ON-SITE SEWAGE DISPOSAL SYSTEM

HOWARD COUNTY HEALTH DEPARTMENT

SUBDIVISION: Triadelphia Woods LOT NUMBER: 30

ADDRESS: 12667 Golden Oak Drive PROPERTY OWNER: John Deleonibus

P524467

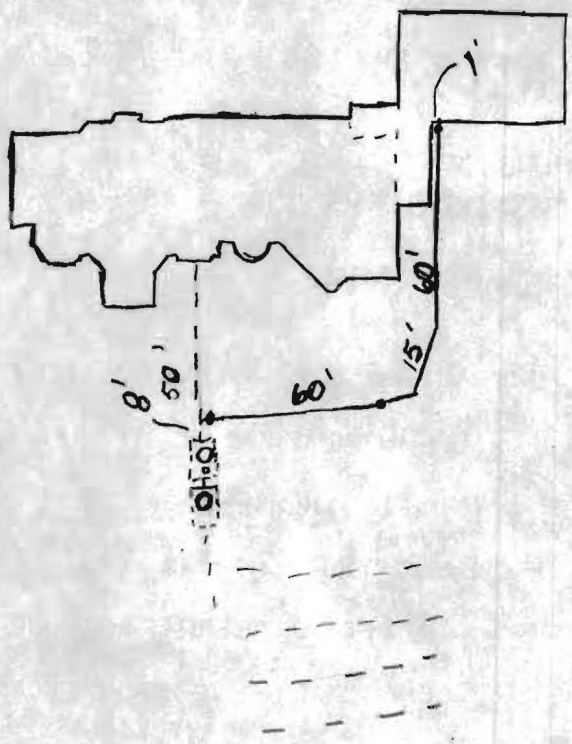
INSTALLATION Install line from new Addition to Existing Septic line. (GAC) Install ok to cover entire line packed in 1" gravel for compaction purposes (GAC)

REV.	
5/4/05	
1/9/06	
4/14/05	
SCALE: 3/16"=1'-0"	
S1

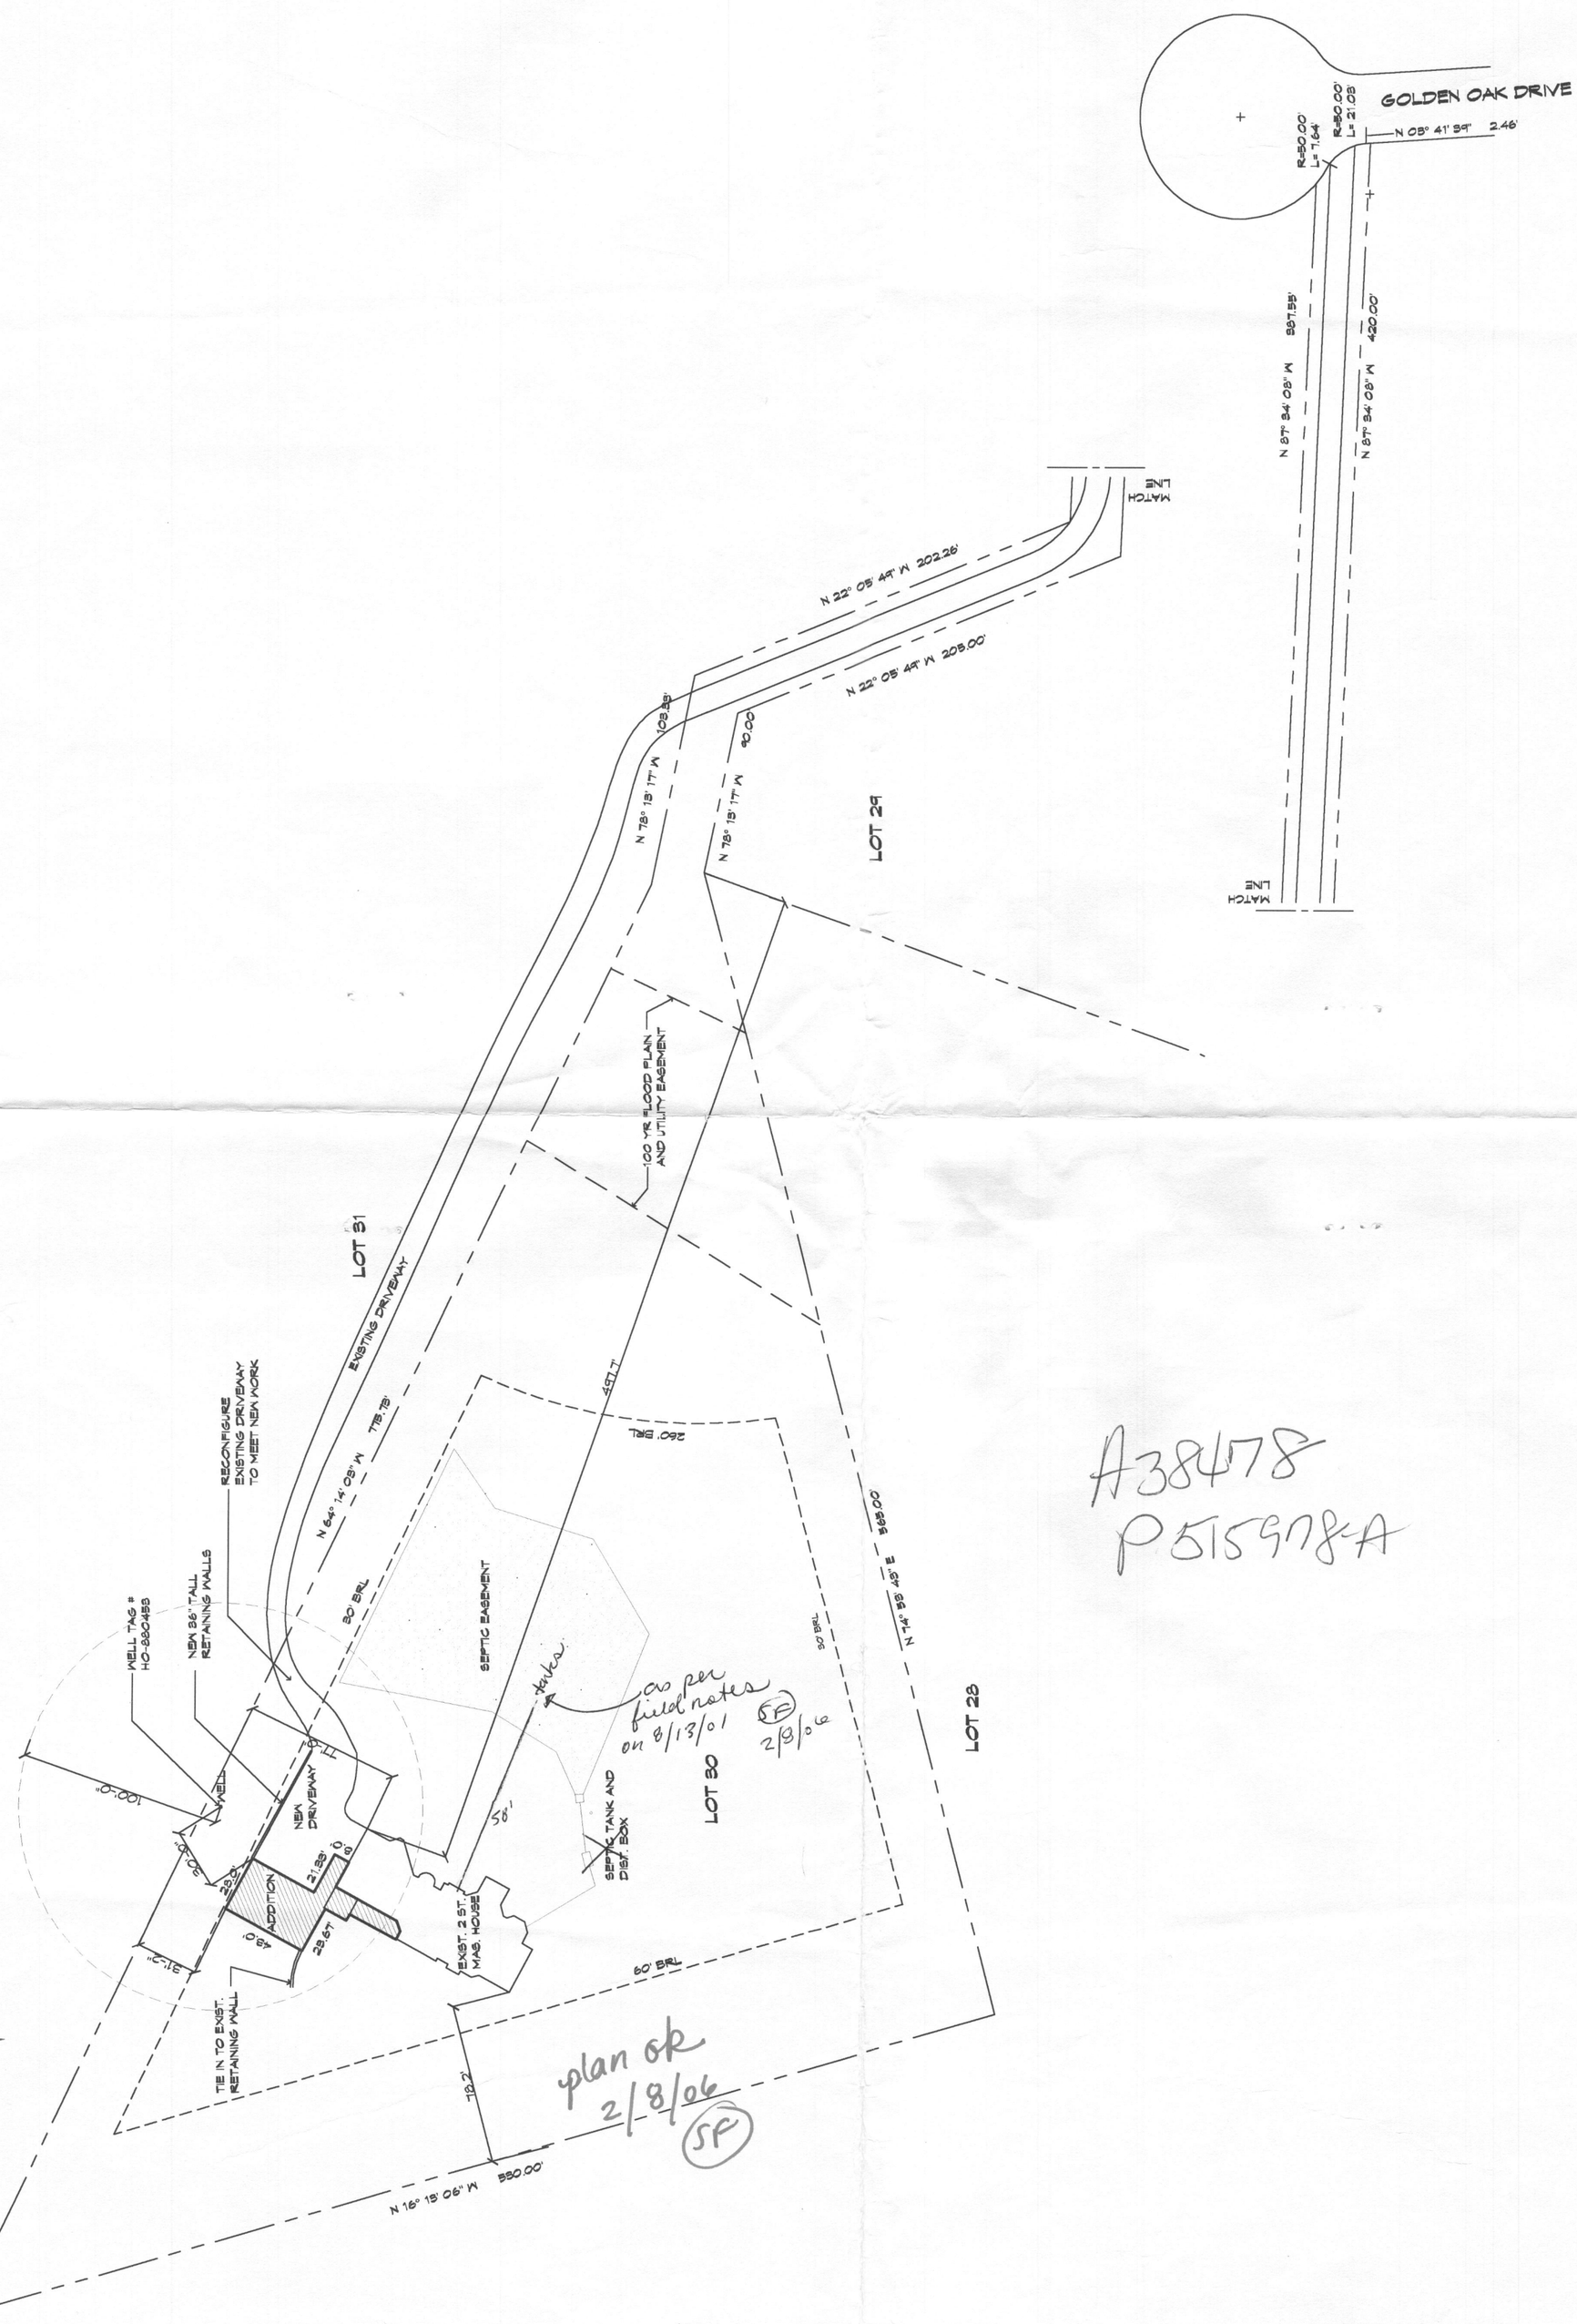
Plan not readable scale

plan ok 2/8/06 SP

- Next addition may need to be upgrade trench system depending on permit description
- ~~Septi tank location not correct~~
- ~~will need to add 250 gal tank.~~
- ~~will need to add addl trench.~~
